January 2021 BAR Decision

BAR 21-01-04

301 East Jefferson Street

Project: Renovations to 3rd Street NE and East Jefferson Street entries

3RD STREET ENTRANCE - ELEVATION

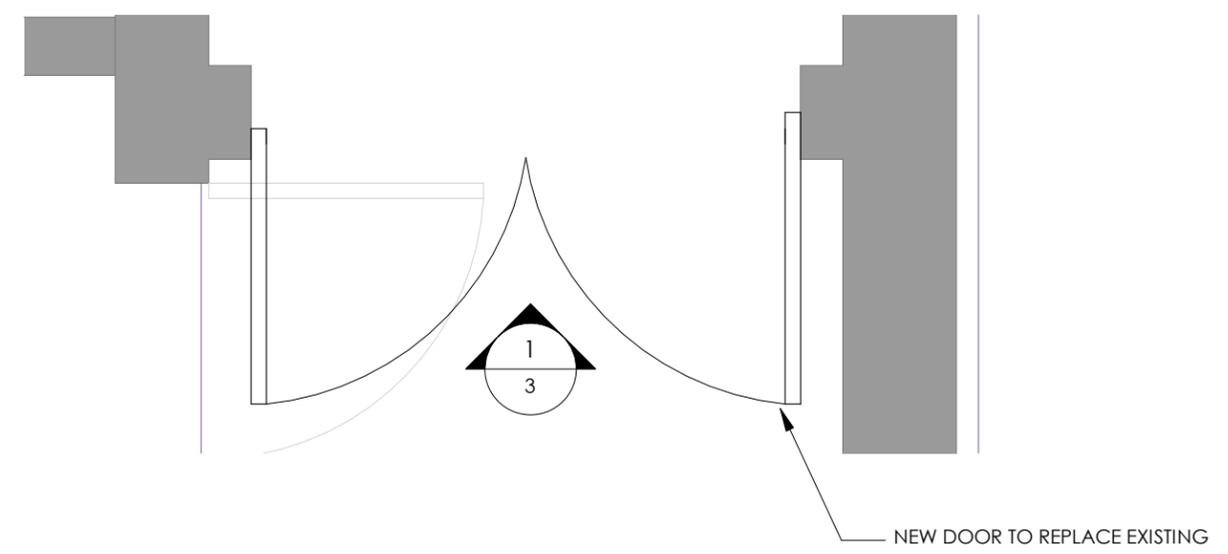
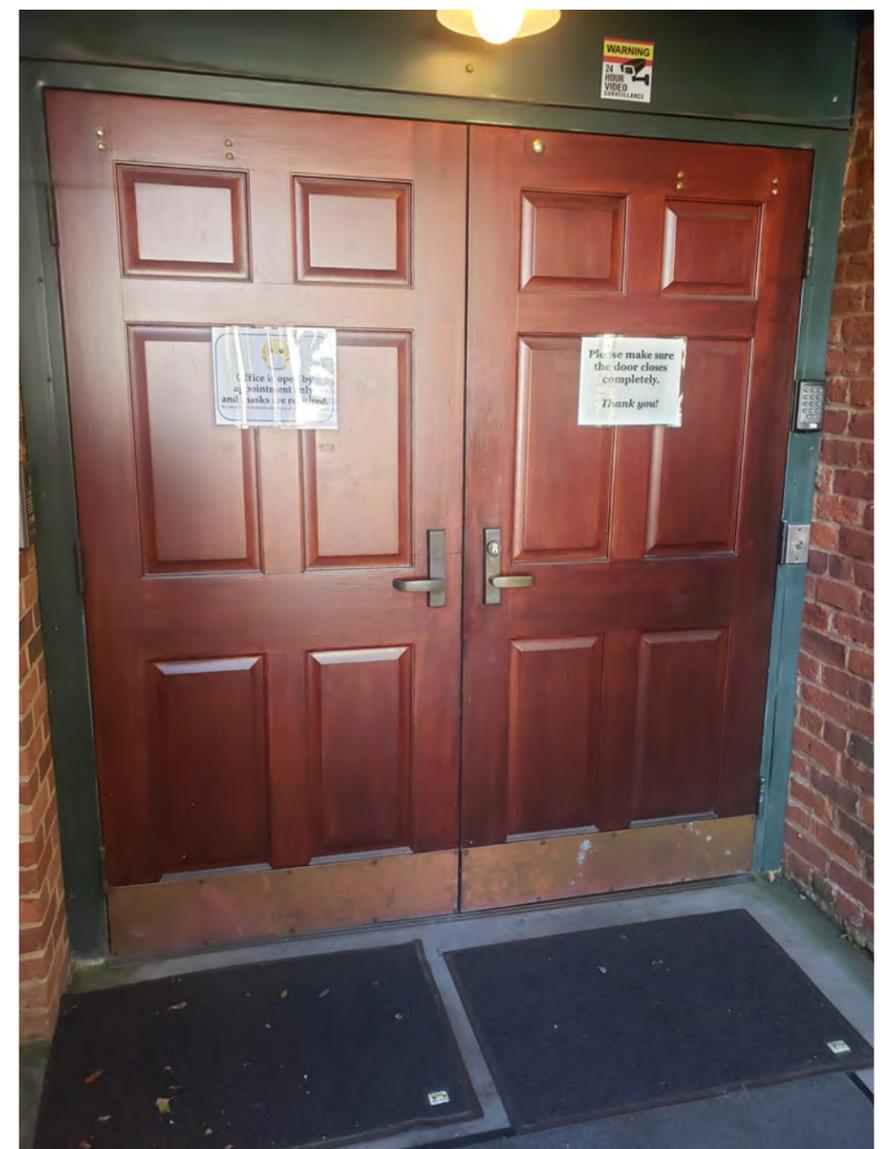
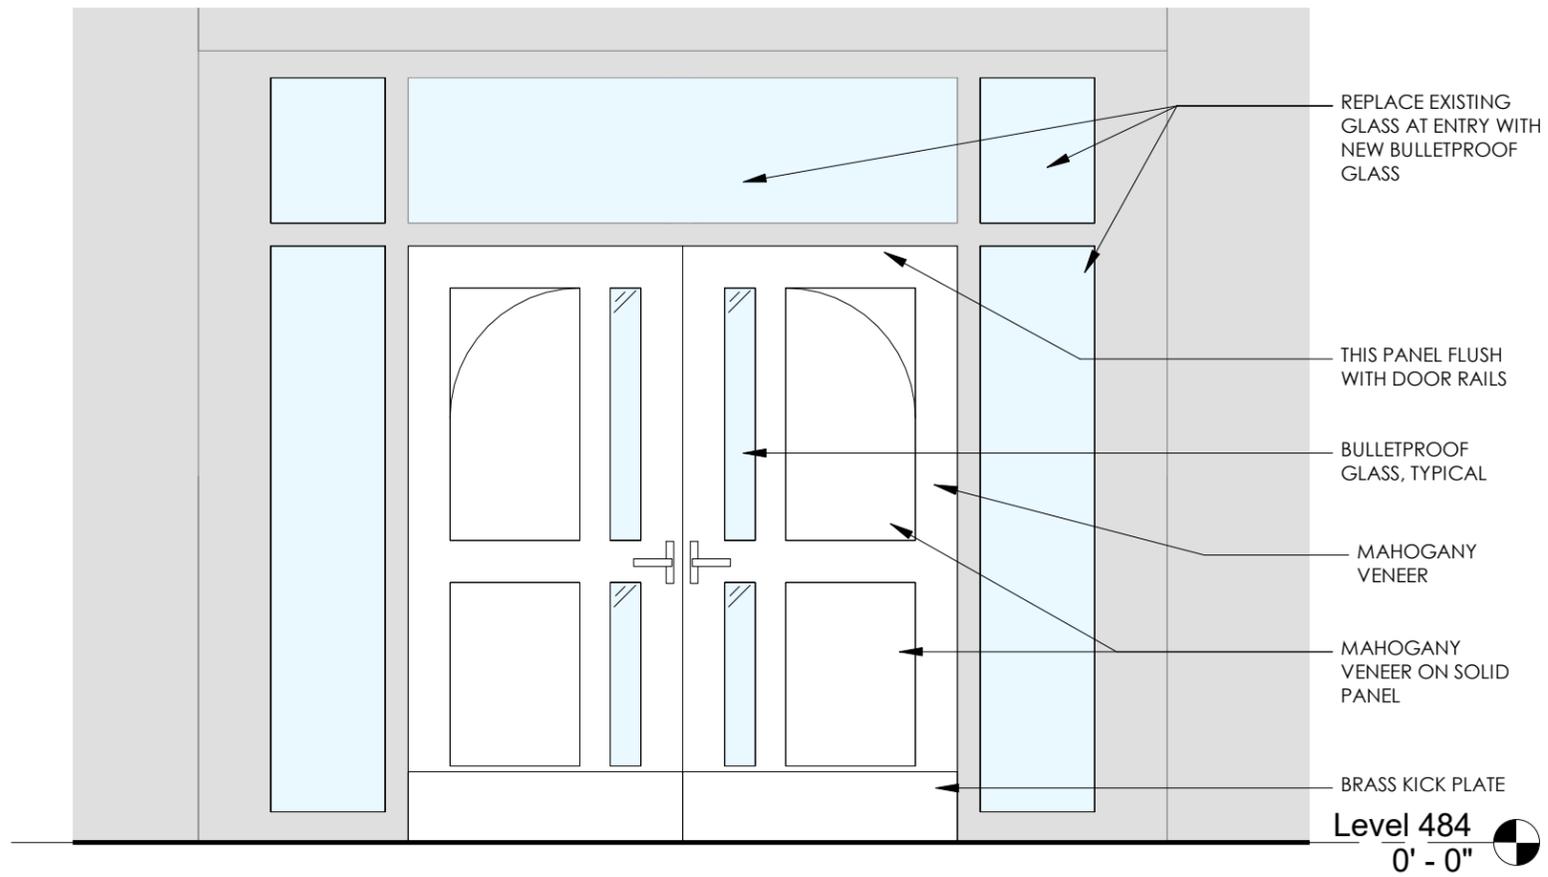
3rd Street side and East Jefferson Lobby entrances. Neither entrance is historic, relative to year built and to the historic temple. (See below from the c1965 Sanborn Map.) With that, staff reviewed these using the design guidelines for New Construction and recommends approval as submitted.
